Certificate of Appropriateness

2616 N. Grant Boulevard, Grant Boulevard Historic District

Replace existing wood fence with 4' solid wood fence with upper 2' 50% open per the attached design.

Fence design

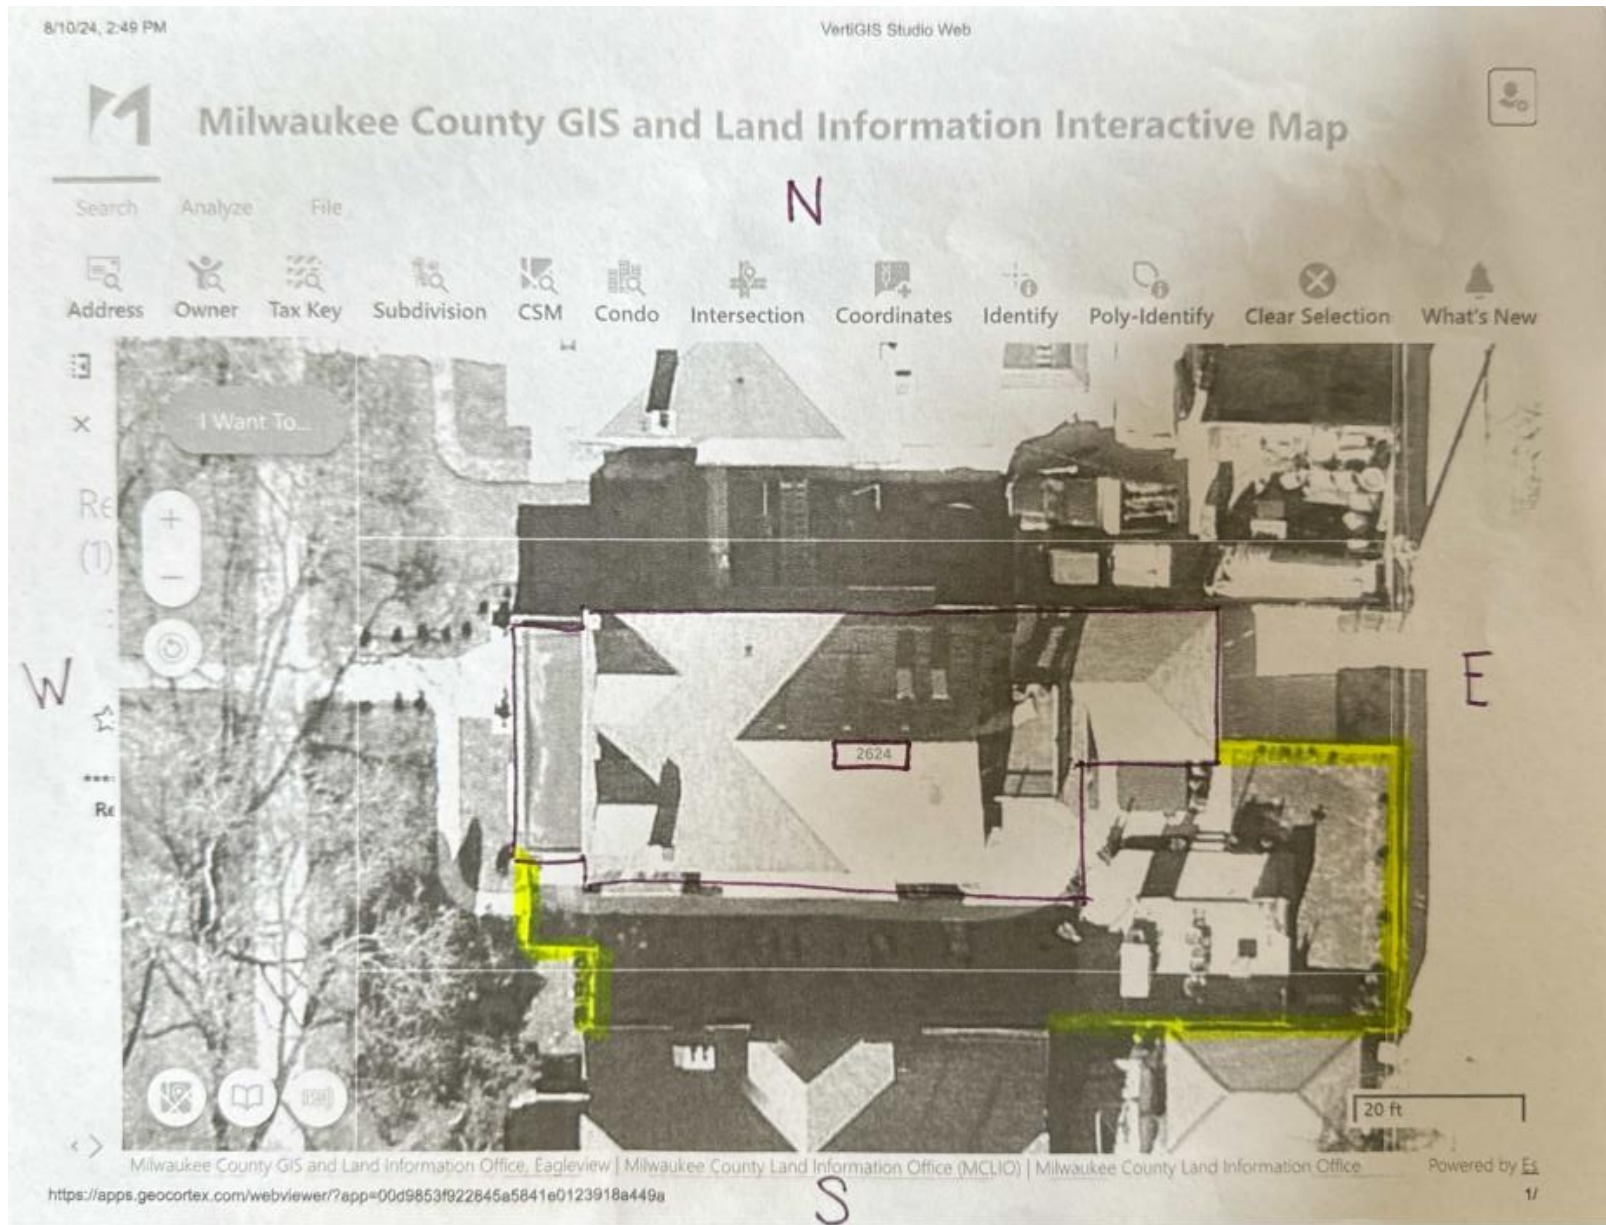
All wood must be smooth and equivalent to #1 grade cedar or better for use in rear and side yards. Sections of fence forward of or in line with the primary building's front setback must be clear grain. Wood fences must be painted or stained upon completion. Note: when new, bare wood is left exposed to the exterior elements for a period of only a week or two, the life of the finish subsequently applied to it will be decreased.
